SUBJECT: MEETING NOTIFICATION AND TRANSMITTAL OF TENTATIVE AGENDA

MAG Standard Specifications and Details Committee
TENTATIVE AGENDA
February 2, 2011

MEETING MINUTES FROM THE
MARICOPA ASSOCIATION OF GOVERNMENTS
STANDARD SPECIFICATIONS AND DETAILS COMMITTEE

2011 PROPOSED REVISIONS TO MAG SPECIFICATIONS AND DETAILS

TYPICAL SECTION AND TRENCH ALIGNMENT

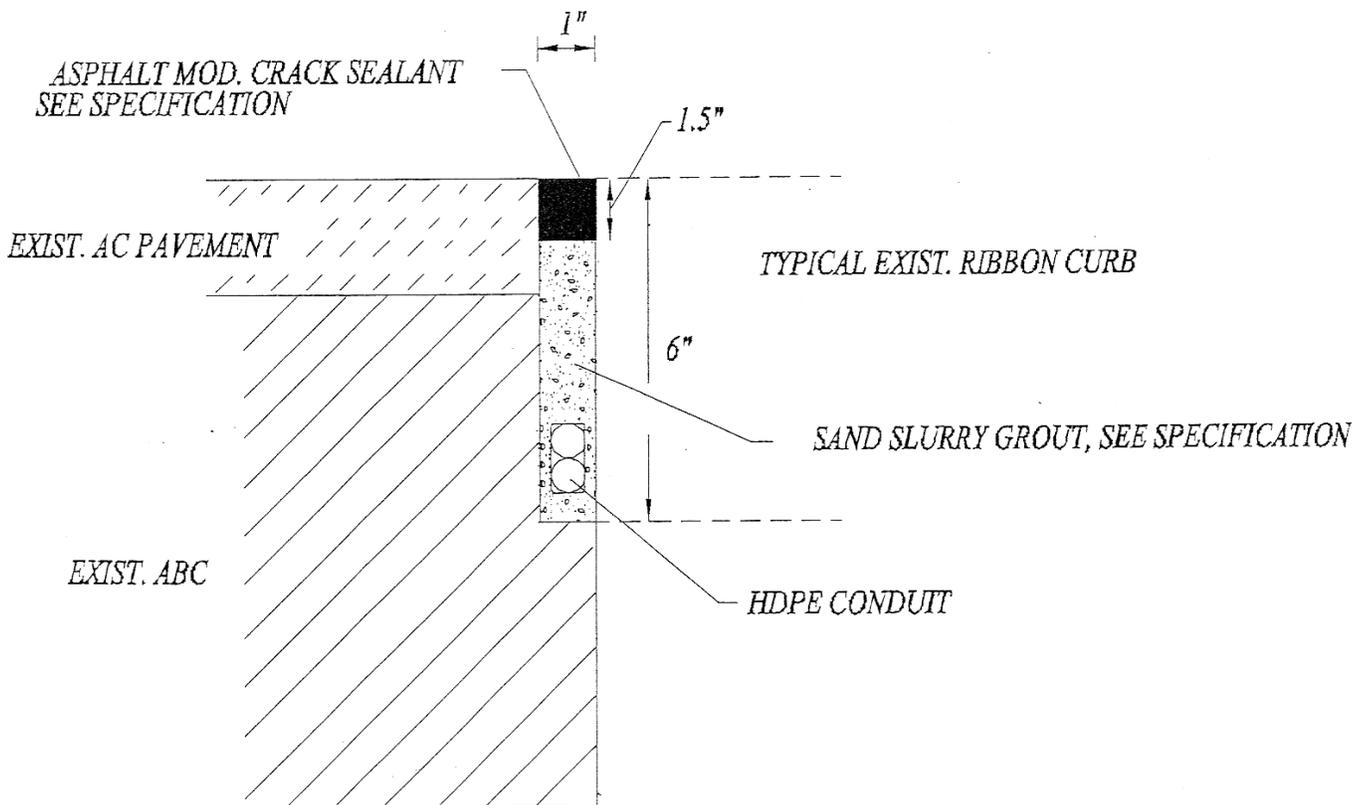
Committee members also questioned him about the location of the cable in the street and of the boxes. Mr. Hernandez said they try to stay at least two feet from the curb (unlike how it is shown in the case detail). Since the process is designed to work in asphalt, they try to avoid installation next to concrete construction such as curbs. He also explained that the distance between boxes was typically 800-1500 feet, and the vaults typically were located out of the roadway and ranged from 24" to 36" in size.

Subject: Proposed addition to Standard Detail 201 – Pavement
 Section at Termination

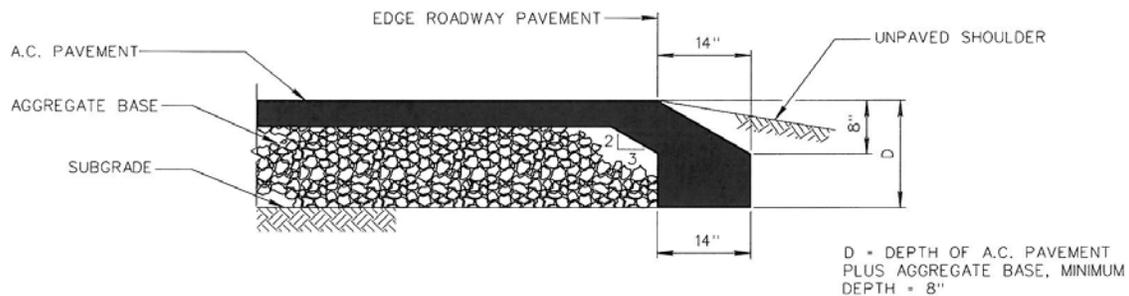
e. Case 11-02 – Safety Edge Detail: *Add an Asphalt Pavement Safety Edge option to Detail 201.* Bob Herz introduced this case to provide another option for the construction of roadway edges. This method reduces an over-correction problem people have when trying to get back onto the roadway after driving on the shoulder. Jesse Gonzales said that he reviewed a couple studies on this issue and provided the following links to them as references.

PURPOSE: Add an Asphalt Pavement Safety Edge option to Detail 201

REVISION: Add Asphalt Pavement Safety Edge Detail.
